London Borough of Camden
Development Management
5 St Pancras Square
N1C 4AG

Objections to the Proposed Development at 75 Lawn Road, NW3 2XB (Application ref: 2020/3726/P) – INCREASED DEMOLITION AND CMP

Figure 1: Approved drawing 2_101 Rev C from App 2 (2018/2136/P) – Ground floor demolition in red

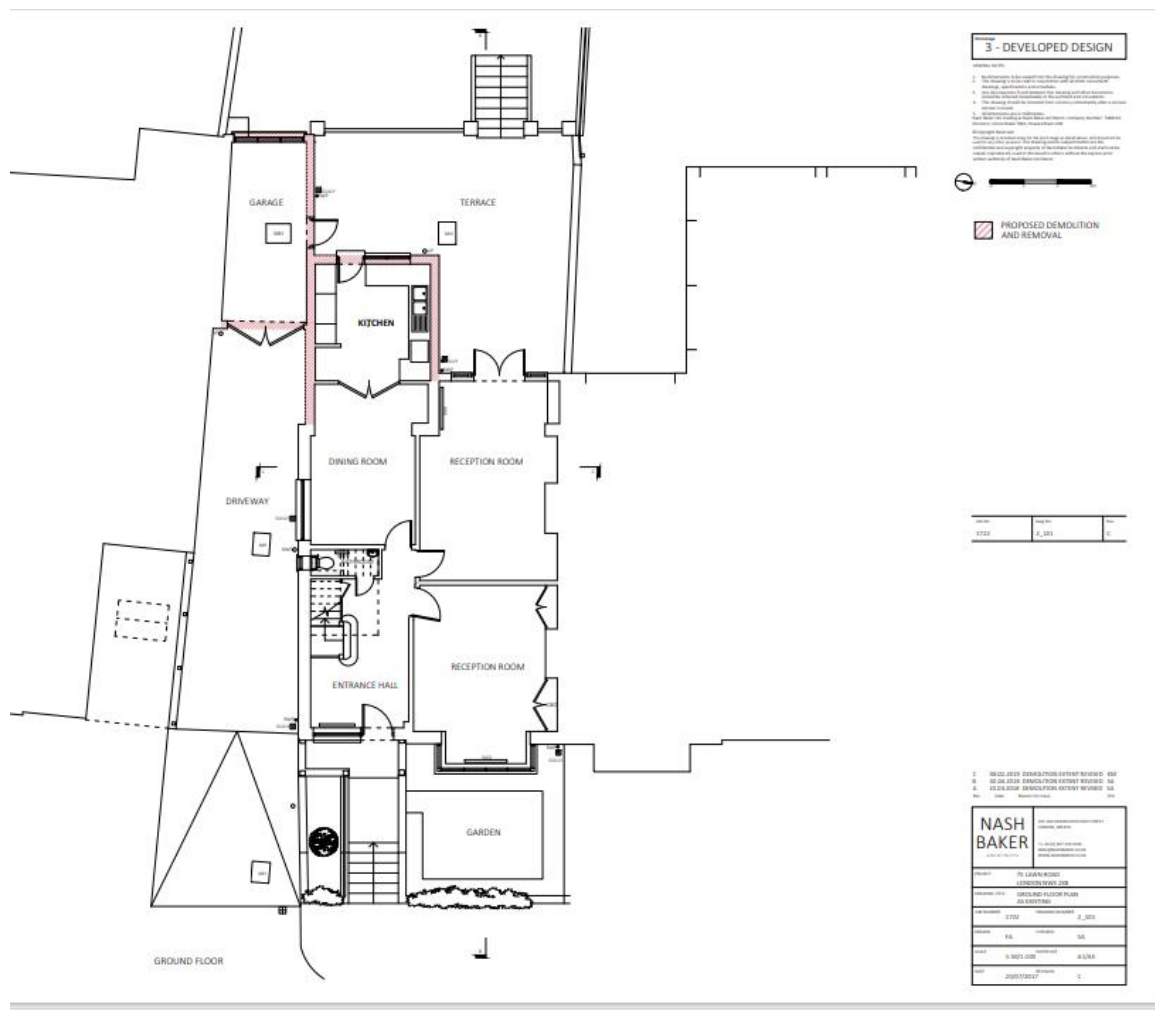
Using the documents that are publicly available on the Camden website we believe that there may be an inconsistency in the applicants' representation of the previously approved extent of demolition. We may be mistaken but ask that Camden checks this before making any decision.

The approval decision letter for 'App 2' (2018/2136/P) dated 2 April 2020 states clearly that Drawing 2_101 Rev C (in the document *Existing floor plans showing revised demolition (amended)*) is the approved drawing. This shows the approved extent of the demolition at ground floor level. This drawing is cut and pasted below as Figure 1, taken from the Camden Planning website. Drawing 2_101 Rev C was also cited in the Legal Agreement between the Applicant and Camden, signed 2 April 2020:

We believe that in Figure 2 the external ground floor wall hatched in red inside our added red circle should be hatched in blue and designated as “proposed additional external demolition” and not “extent of external demolition approved under application 2018/2136/P”.

The fact that this wall will become an internal wall at ground floor level, with a door opening, does not stop this being additional demolition that was seemingly not approved under App 2 (2018/2136/P).

We therefore object to the application to demolish this part of the external wall at ground and/or 1st floor level. At ground floor, much of this wall can be retained under the proposed internal room plans with door openings where needed; at 1st floor level this should remain as the publicly visible external wall of the house, for all the reasons cited by Camden Planning in its pre-application advice letter, which refers to Policies D2 (Heritage) and CC1 (Climate change mitigation).

Figure 4: App 1 (2017/6726/P) – Proposed 1st floor demolition.

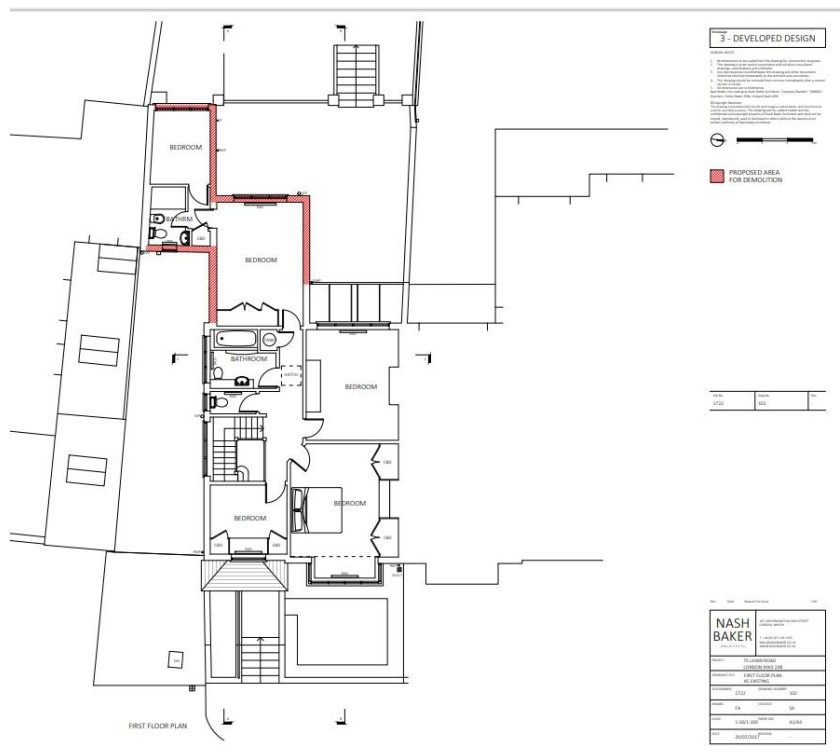
We also think (but have no way of knowing) that the applicants therefore may have made a drafting error when they submitted the revised drawing number 2_102 Revision C (for App 2) and that they meant it at 1st floor level to be identical to the equivalent drawing for App 1 i.e. App 1 drawing number 102. Figures 4 and 5 show the relevant excerpts for App 1 and App 2 respectively, with the difference highlighted by our red circle. It is the omission in Figure 5 at 1st floor level, which was included in Figure 4, that we are referring to.

- We do not oppose this specific element of additional demolition i.e. in line with Figure 4 above. It is the only part of the outrigger that would not be demolished and the supports needed for its retention do not contribute to the retention of the other walls where additional demolition is being requested, to which we object.

Figure 5: App 2 (2018/2136/P) – Proposed 1st floor demolition. Difference with App 1 (Figure 4) highlighted by our red circle

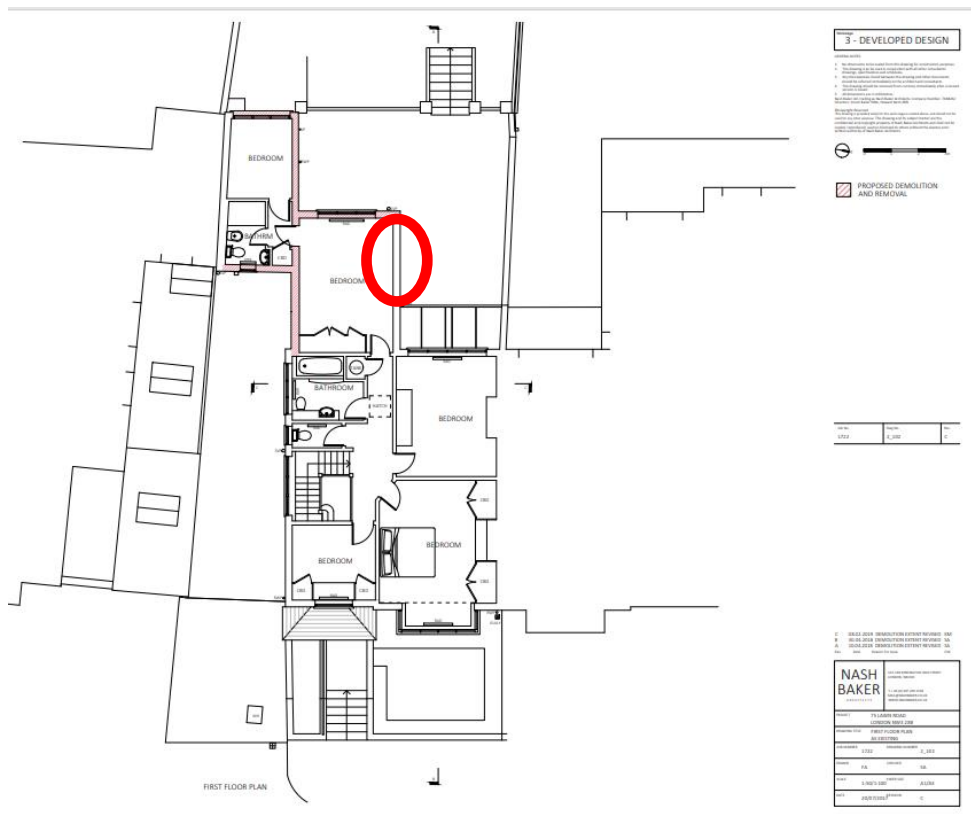
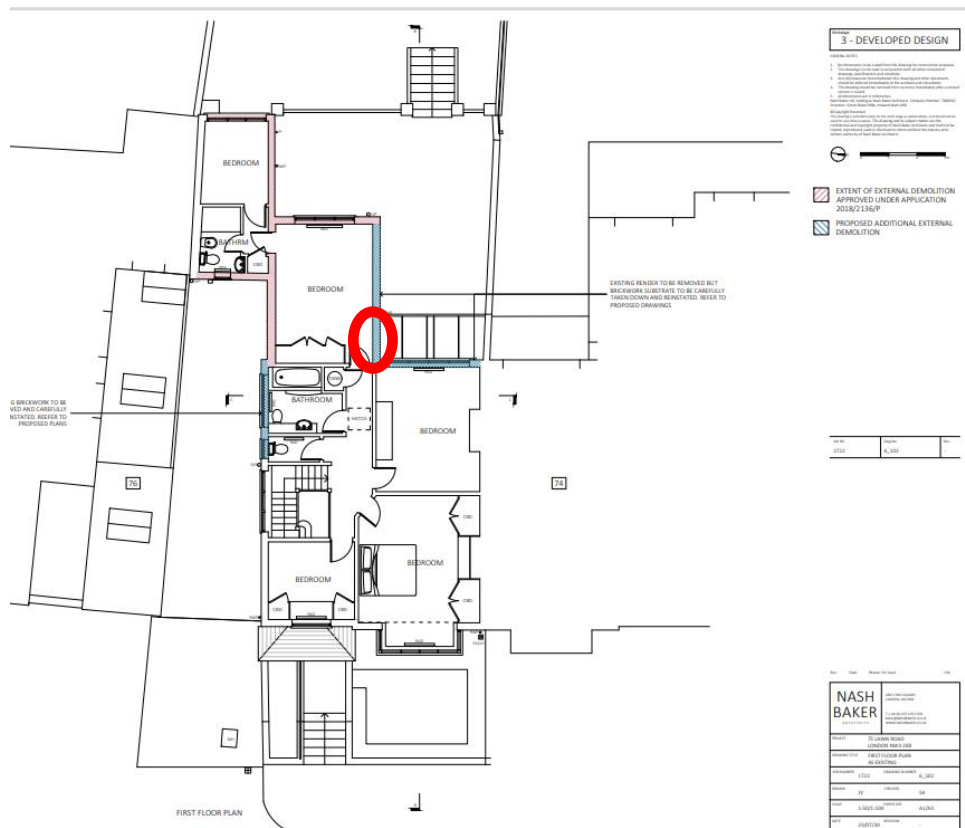
- We think that in fairness to the applicants it should be established whether it was intended that App 2's *Existing floor plans showing revised demolition (amended)* should differ from the demolition as proposed in App 1; and whether Camden intended for this section of 1st floor wall on the outrigger to be retained.
